Gravity Probe B Relativity Mission

### GMA Recovery Plan

S0590 Rev. -

Figure 1: Proposed Change to the GMA Architecture

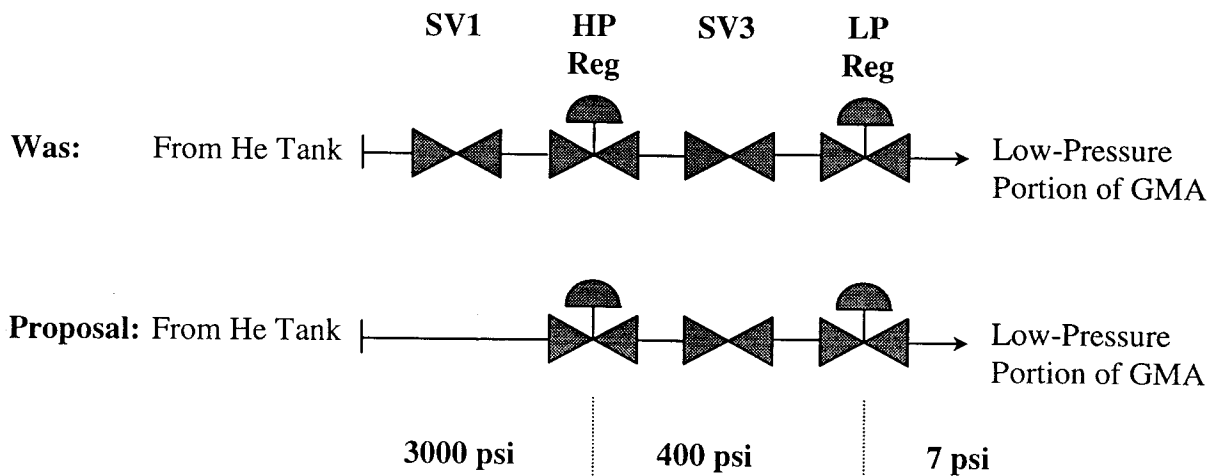
### Issue #1: The High Pressure Latching Valves do not operate at required pressures

The root cause for this anomaly has been found to be a design flaw in the valves, in which outlet pressure greater than 800 psi exerts sufficient force to close the solenoid valve. Although it is possible to modify the internal design of the valve to overcome the problem, this has been determined to not be a viable solution from both cost and schedule viewpoints. We identify two potential fixes to this issue. Option #1 (discussed below) is the preferred option. However, some additional work must be performed to show that it is viable and meets requirements. Option #2 is a backup plan.

The first is to remove the two high-pressure solenoid valves (one for each parallel path) which are one the tank side of the high-pressure regulators. Figure #1 shows the change in architecture (only one of two redundant paths shown).

In this scenario, SV3 serves as the shutoff valve for the system, and the regulator flies with Helium gas on both sides. There are two things which must be demonstrated before this can be adopted as the new baseline.

- Having Helium on both sides of the regulator alters the force margins at launch, so the regulator design must be qualified to operate in this mode. This qualification should consist (1) of analysis to understand the force margins and arrive at the viable pressure configuration, and (2) a set of qualification tests on a backup flight regulator to demonstrate the design meets requirements. The general plan is to build a manifold as outlined in Figure 1 using spare flight parts and conduct the qualification tests on the whole manifold, to properly include all possible system-level effects.

- Demonstrate that the input of the low-pressure regulator can accommodate the maximum pressure to which it may be exposed. Here, a worst-case analysis must be performed which assumes that the HP regulator-SV3 space is at 3000 psi (the highest pressure is any portion of the system), and then it should be shown that the LP regulator can handle the resultant pressure when SV3 is opened. Note that inspection of the design indicates this should not be a problem, although excessive pressure at the *output* of the LP regulator would be cause for concern. Experimentally, this will be verified with the qualification test mentioned in the previous bullet.
